HISTORIC AND DESIGN REVIEW COMMISSION

HDRC CASE NO: 2021-195

ADDRESS: 1901 N NEW BRAUNFELS AVE

TYPE OF WORK: Replacement of building tile

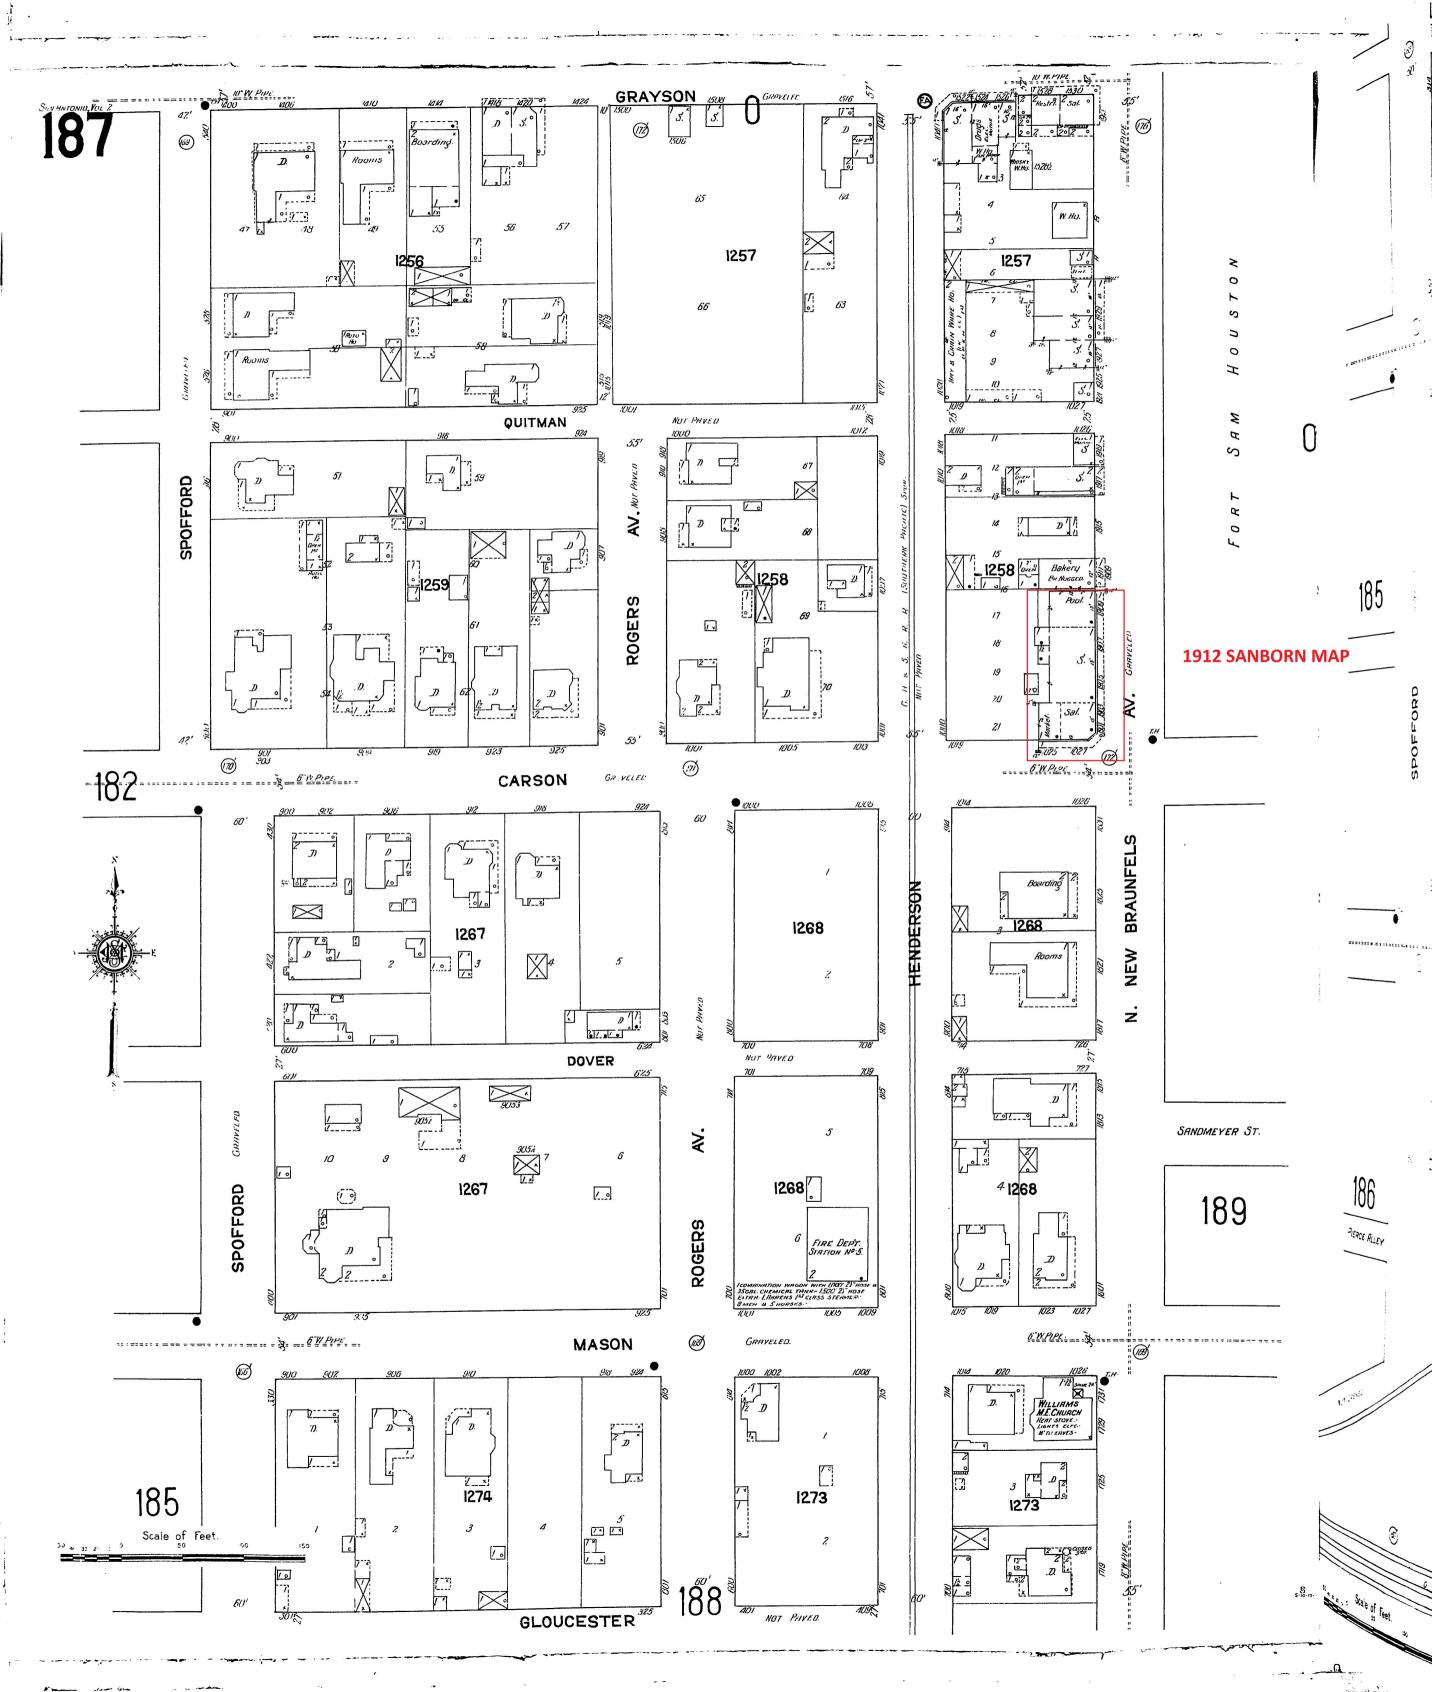
- a. The historic structure at 1901 N New Braunfels was constructed circa 1910 and is first found on the 1912 Sanborn Map. The historic structure features one story in height, a storefront system and sidewalk canopy. The historic structure features historic tile at some locations, which other locations feature replacement tile or no tile.
- b. TILE REPLACEMENT/INSTALLATION The applicant is requesting a Certificate of Appropriateness for approval to install new, wainscot tile at 1901 N New Braunfels. In locations where the historic tile still exists, the applicant has proposed to install the new tile on top of the existing, to preserve the existing in place. Per the Guidelines for Exterior Maintenance and Alterations 10.A.i., applicants are to preserve character defining

features such as cornice molding, upper-story windows, transoms, display windows, kickplates, entryways, tiled paving at entryways, parapet walls, bulkheads, and other features that contribute to the character of the building. Additionally, per the Guidelines for Exterior Maintenance and Alterations 10.B.i. applicant should not introduce new facade elements that alter or destroy the historic building character. Staff finds the installation of matching tile where tile does not exist or where tile is non-original to be appropriate and consistent with the Guidelines; however, staff finds the installation of new tile on top of existing, original tile to be inconsistent with the Guidelines. Staff finds that original tile should be repaired.

Staff recommends approval of the installation of new tile where tile currently does not exist, or where non-original tile is located; however, staff does not recommend approval of the installation of new tile on top of existing, original tile.
